City of Miami Beach
Last Completed Item Reviews Across All Submittals

Permit Type: Building - Commercial **Work Class:** Alteration (w/o Phased) **Application Date:** 05/22/2020 **Status:** Approved
Address: 235 WASHINGTON AVE **Permit:** BC2013662

Re: Response to City Comments.

Sobe Hostel
235 Washington Ave.
Miami Beach, Florida

Sheet Number: M-1 1 OF 2

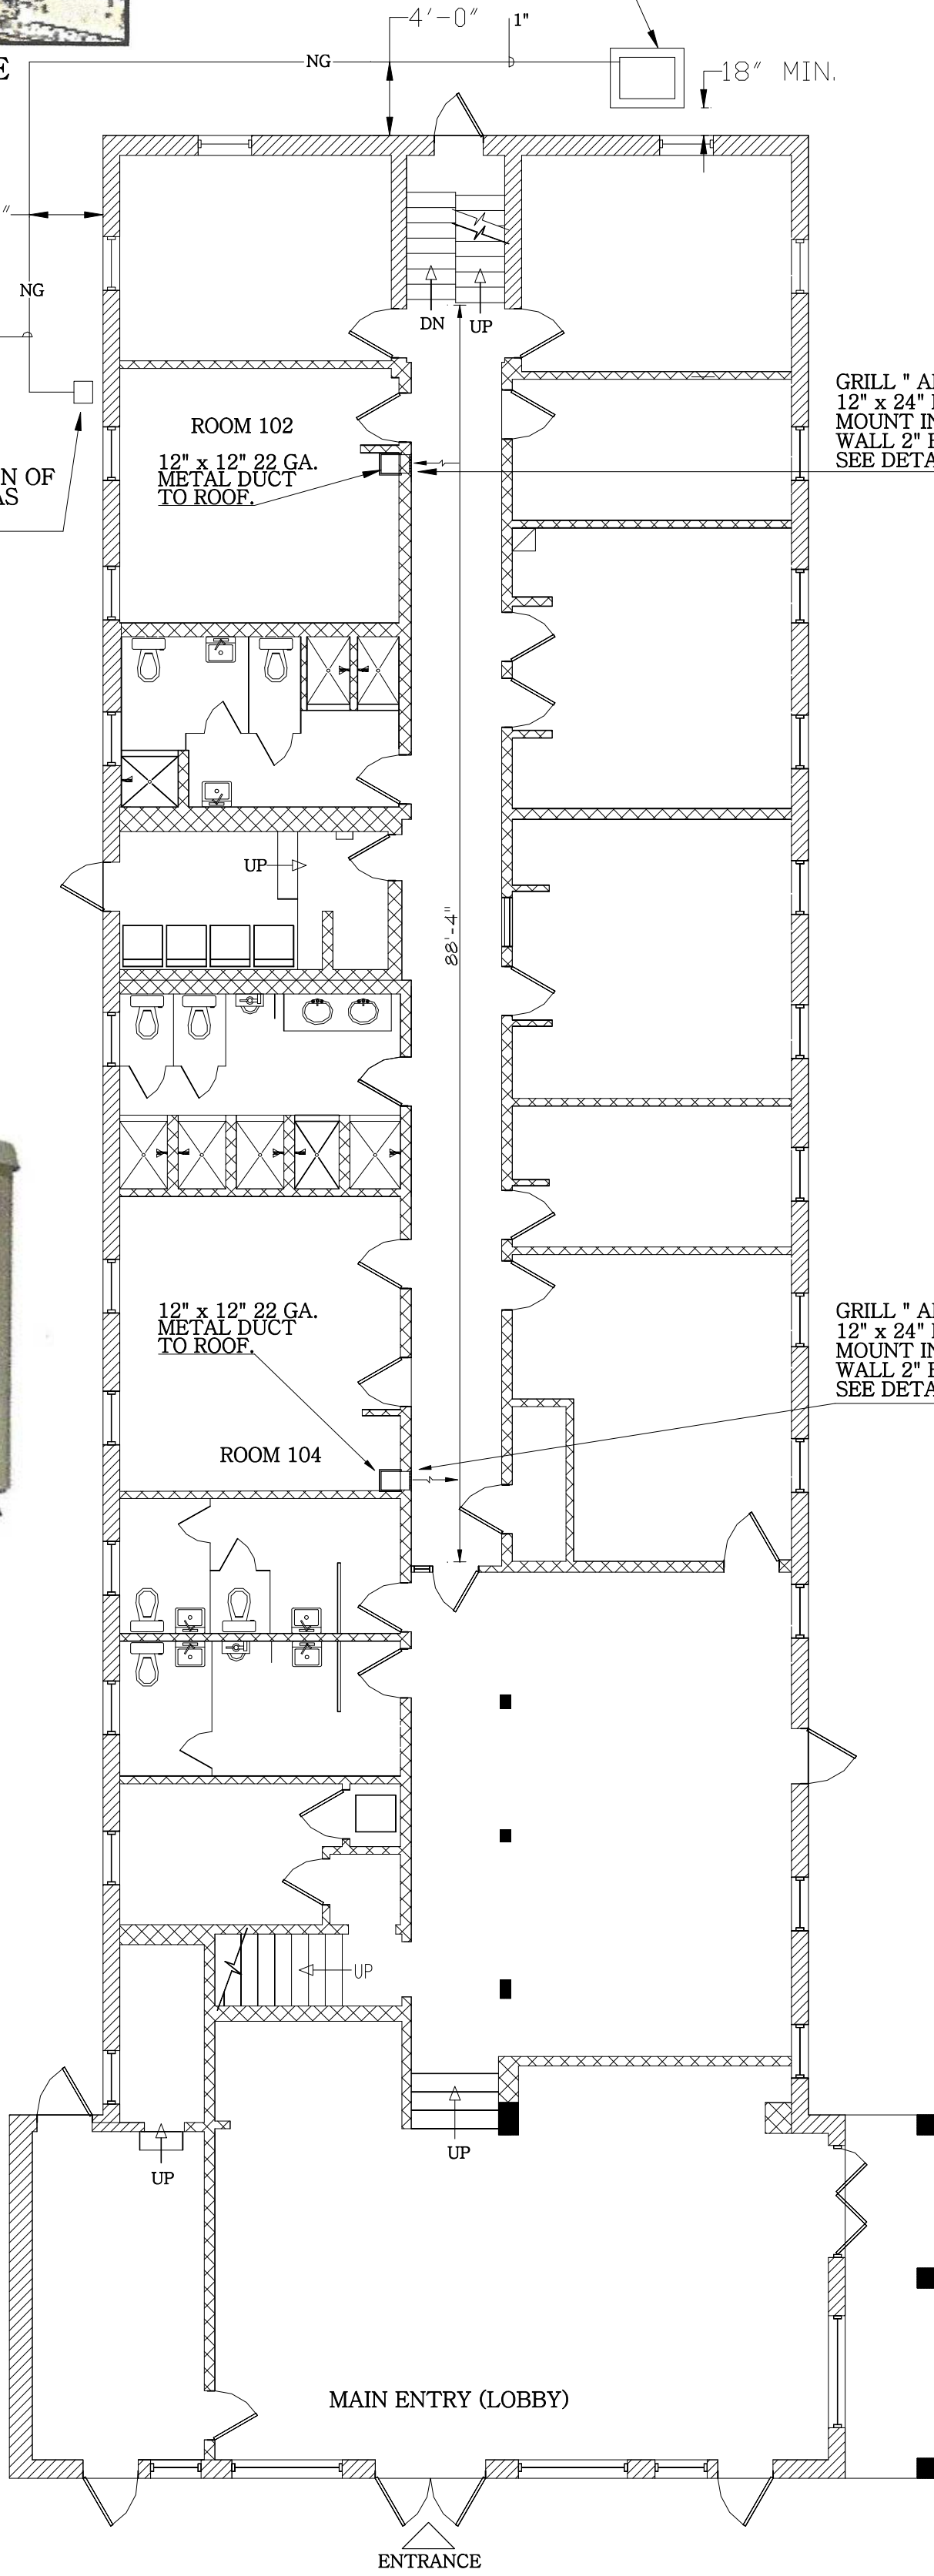
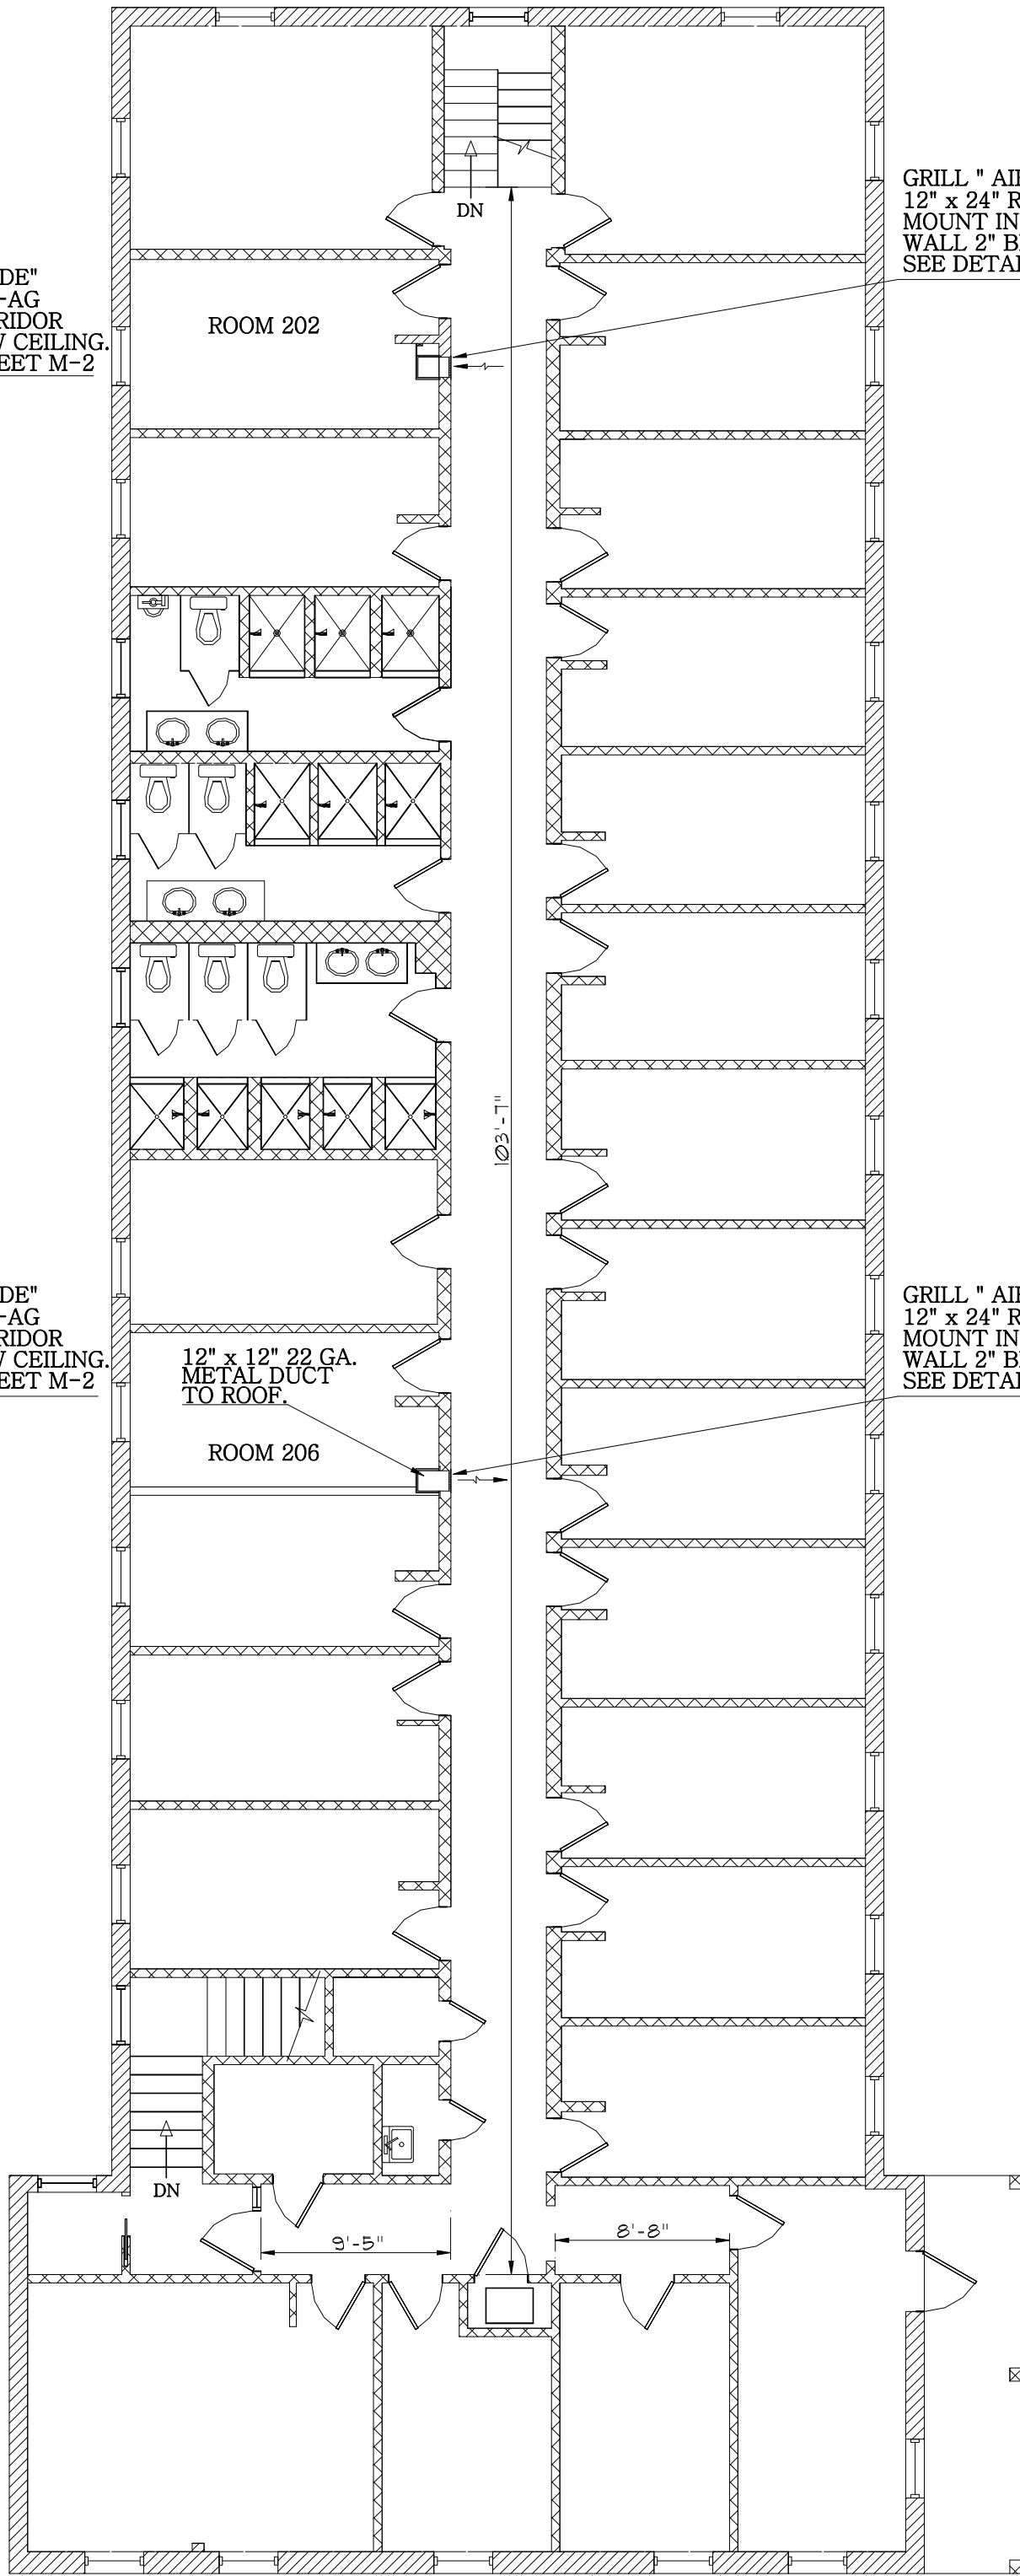
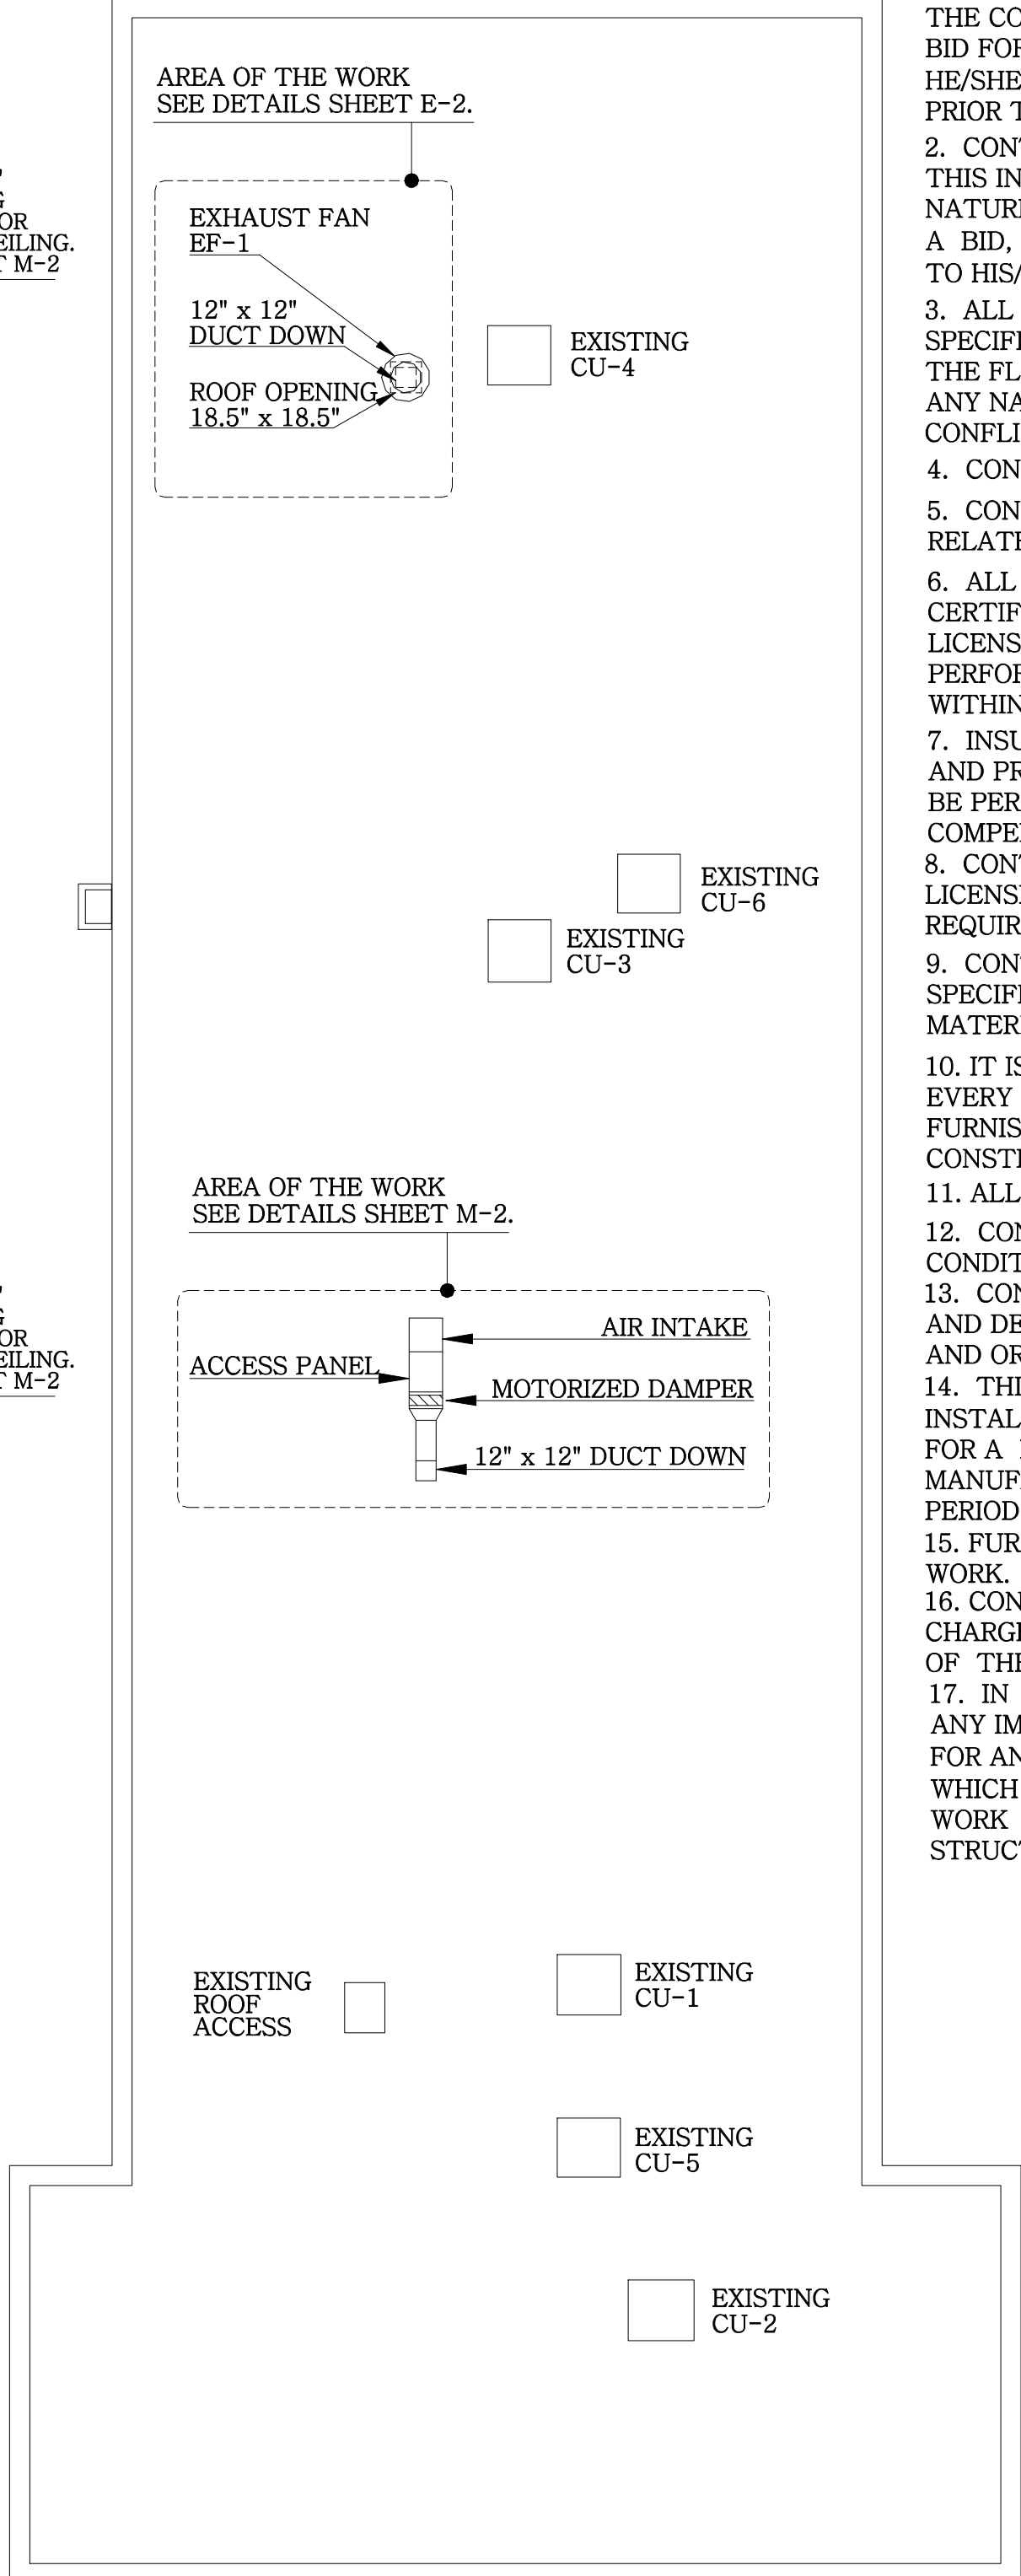
3. The smoke exhaust system push button is located in a space off the lobby next to the existing Fire Alarm Panel and is clearly marked on the First Floor Plan sheet E-1 and Sheet M-1.

6. Outdoor ductwork requirements are included in the SMACNA manual for ductwork. Refer to Note 2, Sheet M-1.
7. Section lines were not included on Sheet M-2 for clarity. They have been added as instructed.
